# First Church Roxbury John Eliot Square

Amend Application 19.688.122 to include drainage work including installation of bio-retention area.

# BLC questions to address

*Archaeological Survey - June 2019*

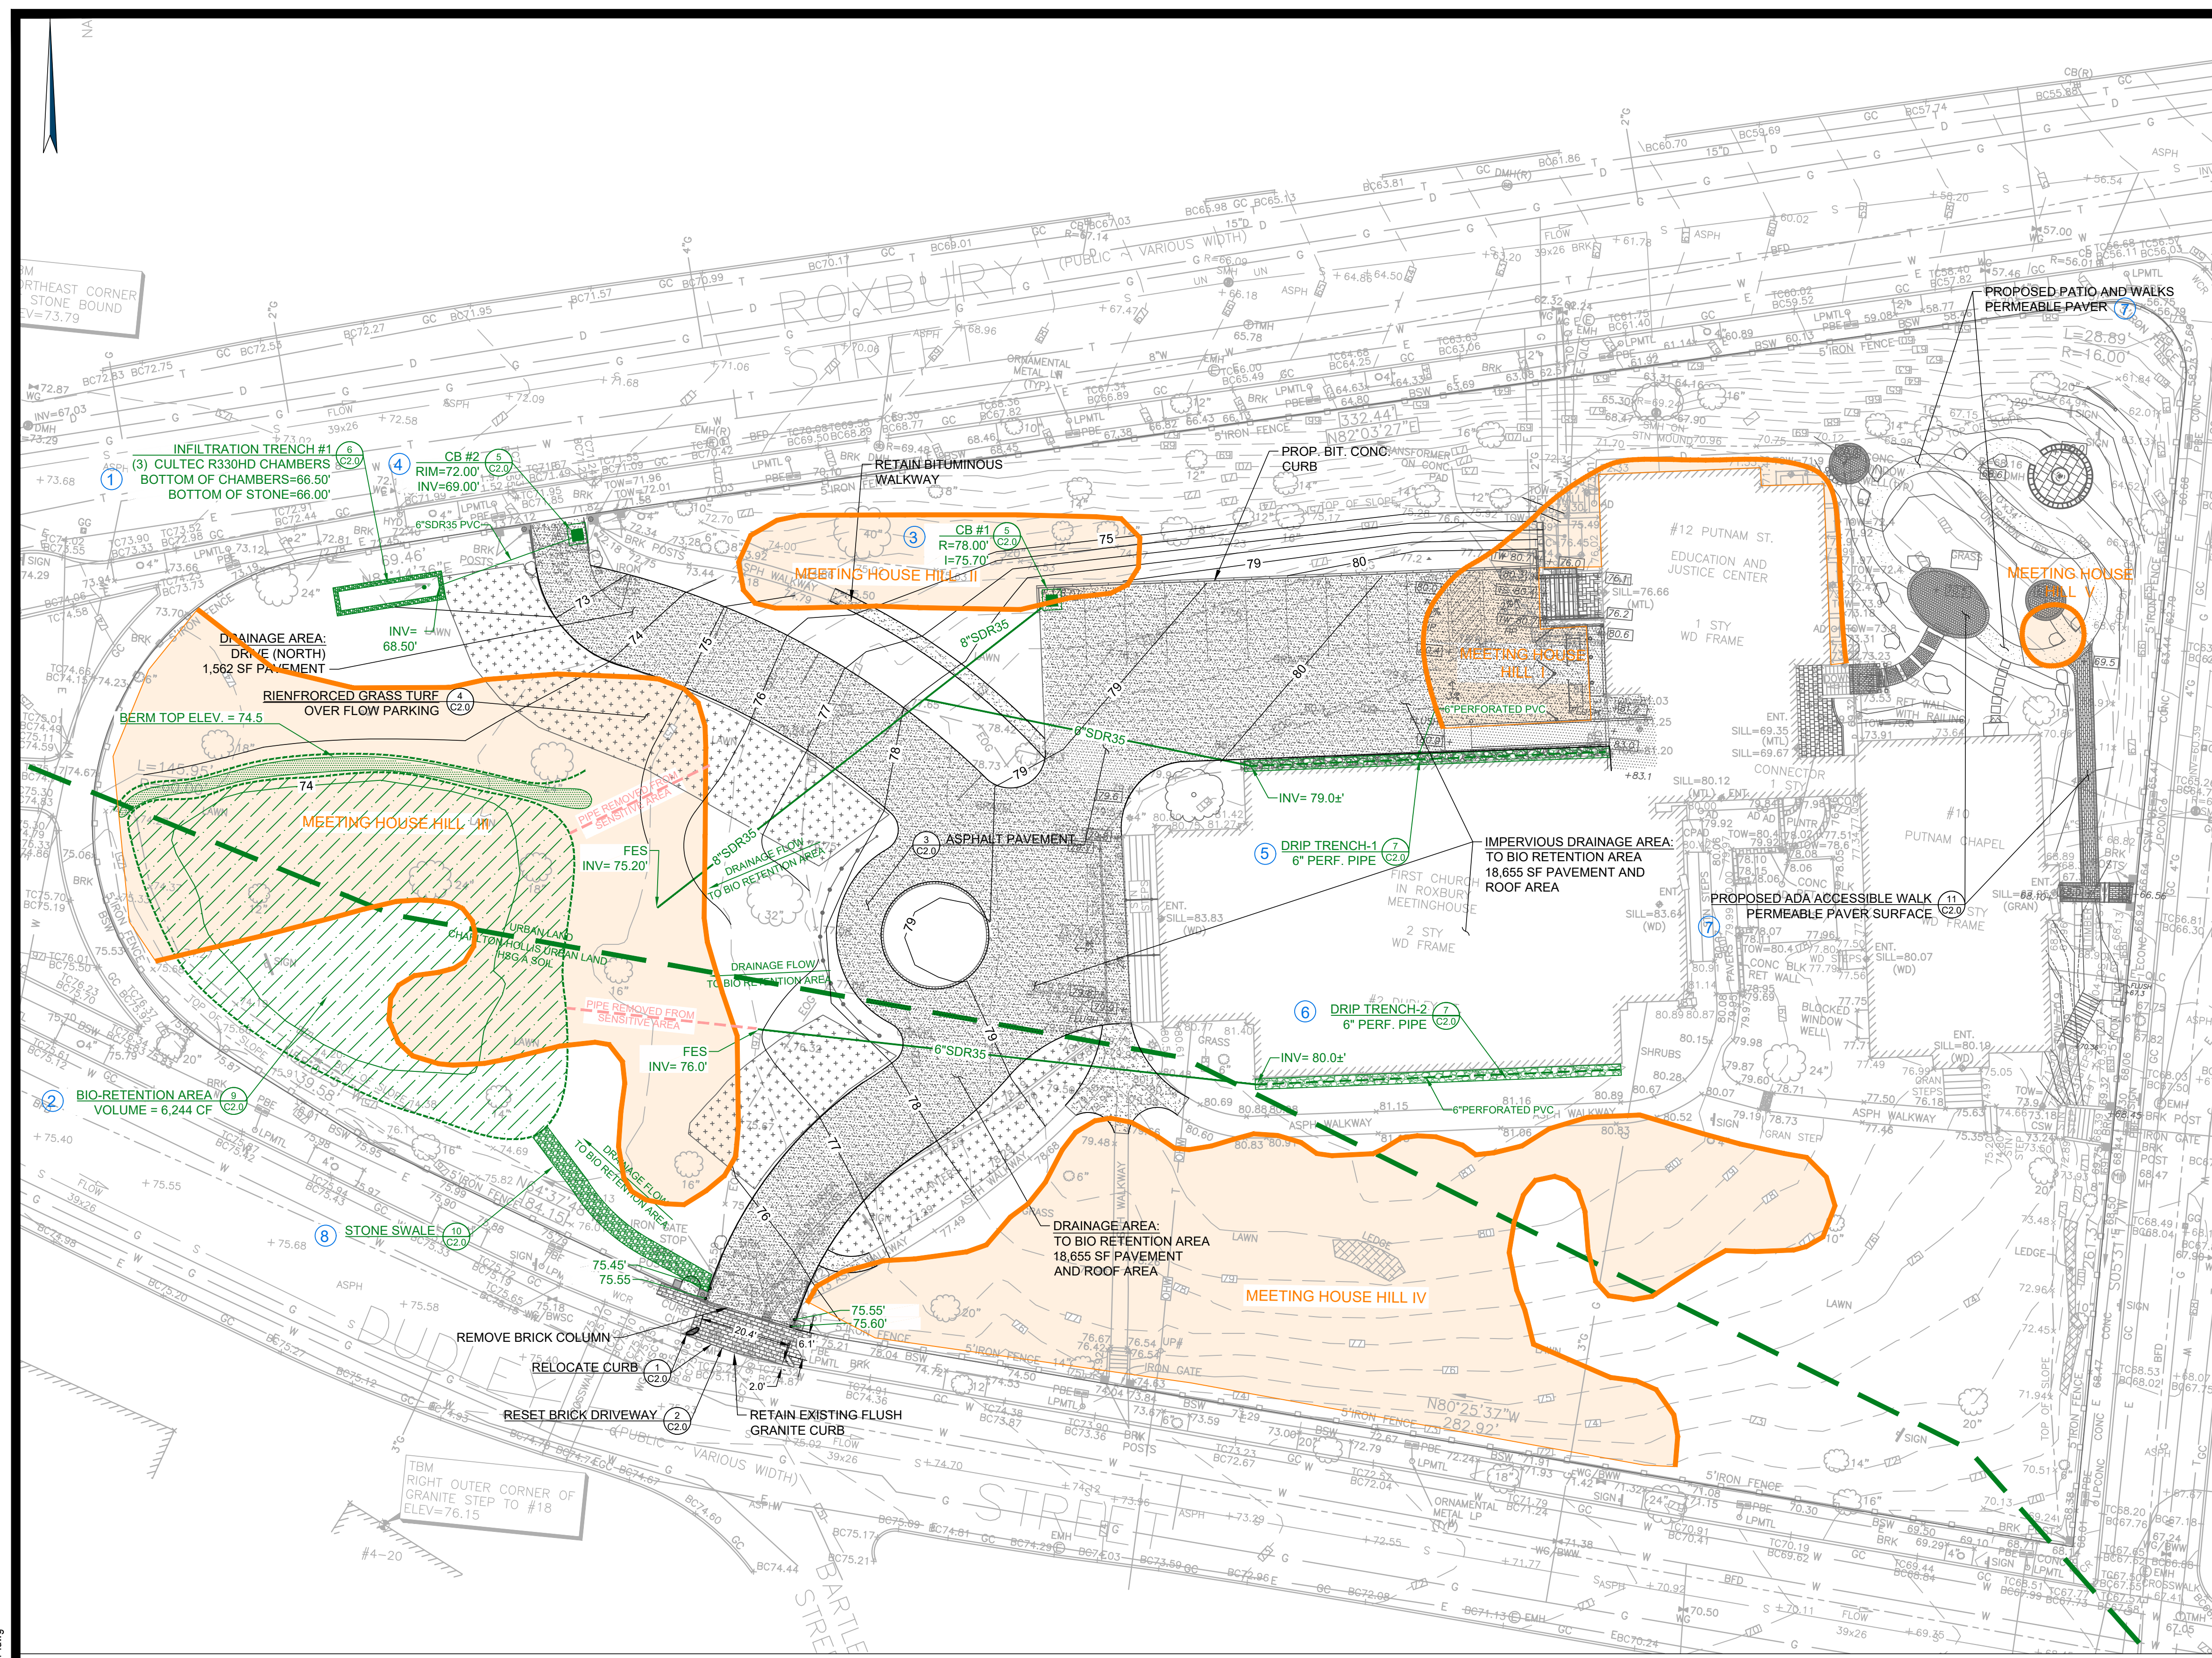
Confirm ADA compliant ramp in Contemplative Garden, will not be removing soils from the site.

The proposed stone dust walk and brick sitting area will be constructed without more than 12" of excavation within the protected area.

*Southeast Yard and Garden: Due to the area of preserved Native site, it is recommended that below-ground impacts be avoided that extend deeper than 30 cm (12") in the southeast corner of the zone. The surrounding area does not appear to have archaeological integrity.*

**C1.0**

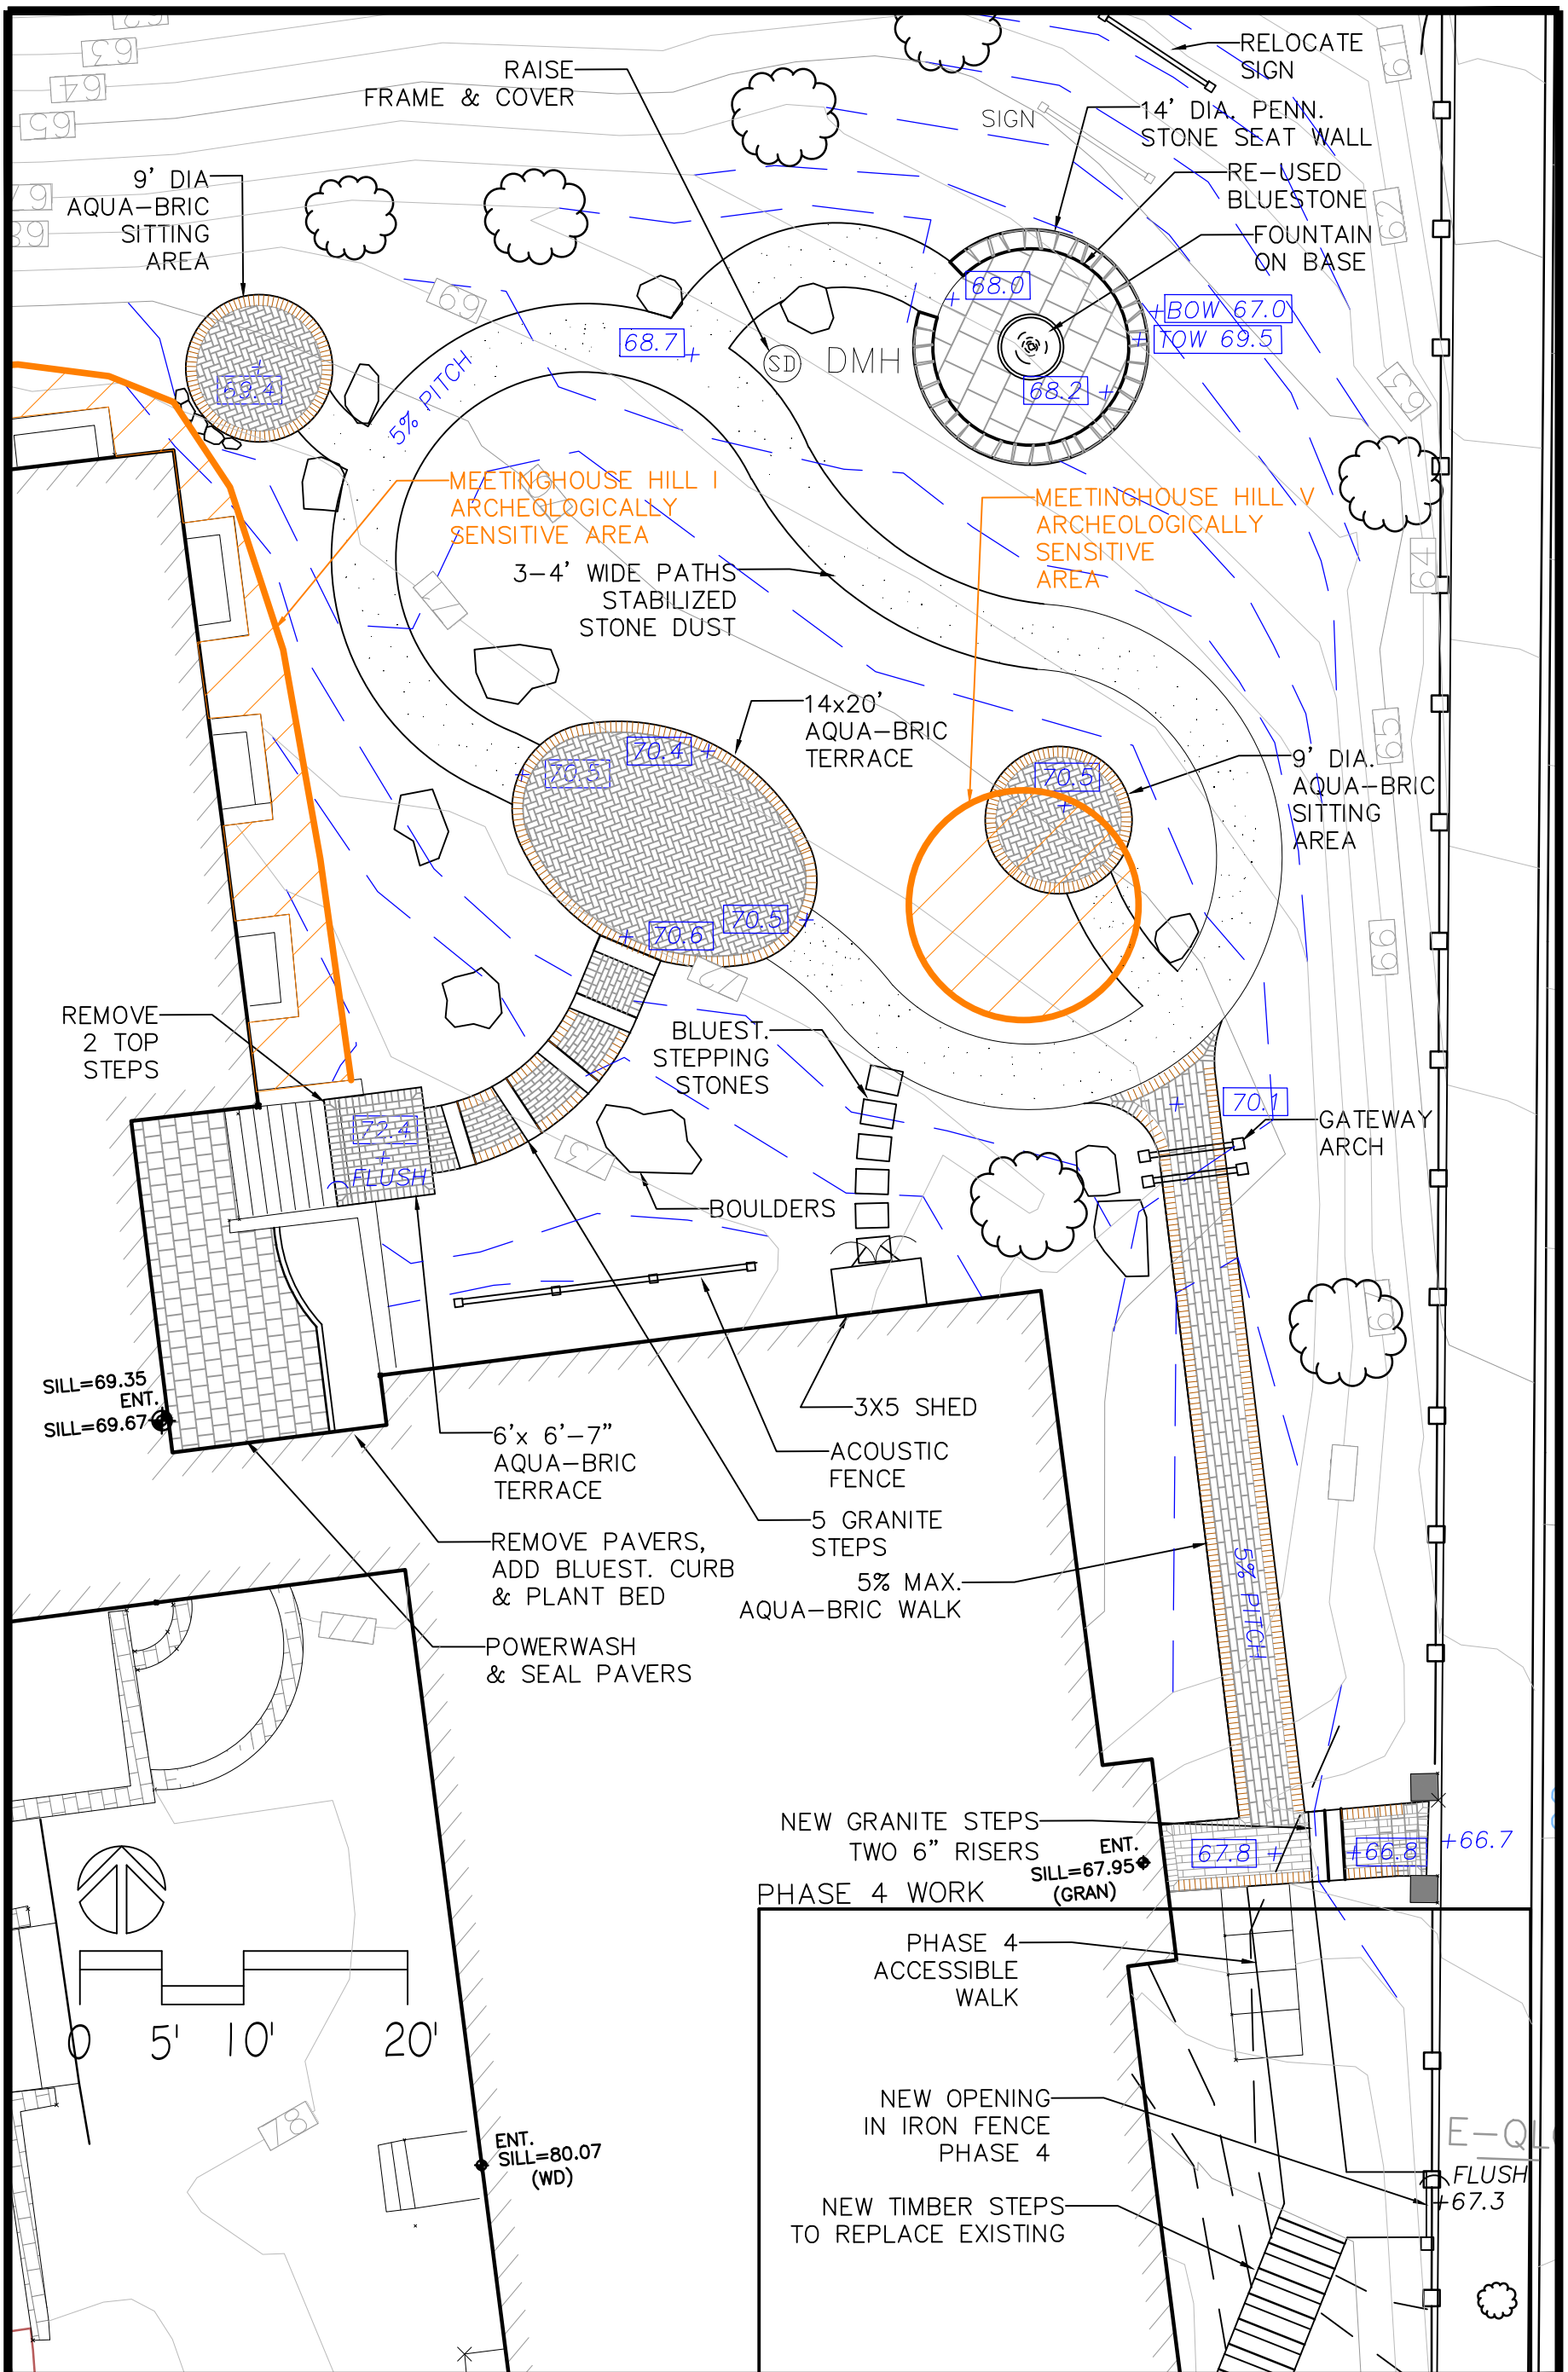
What are the width and depth of pipe trenches that extend from the North and South sides of the Meeting House to the bio-retention area?

Drainage pipe trenches will average 24"- 36" deep and 12"- 18" wide. Redesign will allow the drainage pipes to either terminate *outside* Meetinghouse Hill III entirely, or will limit excavation to less than 6 inches deep within this protected area. The 6" SDR35 drain will terminate outside Meetinghouse Hill III. The 8" SDR35 drain pipe extends only 12 feet into Meetinghouse Hill III and requires *less than 6"* excavation to install the pipe and the splash pad within this protected area. See updated BWSC site plan.
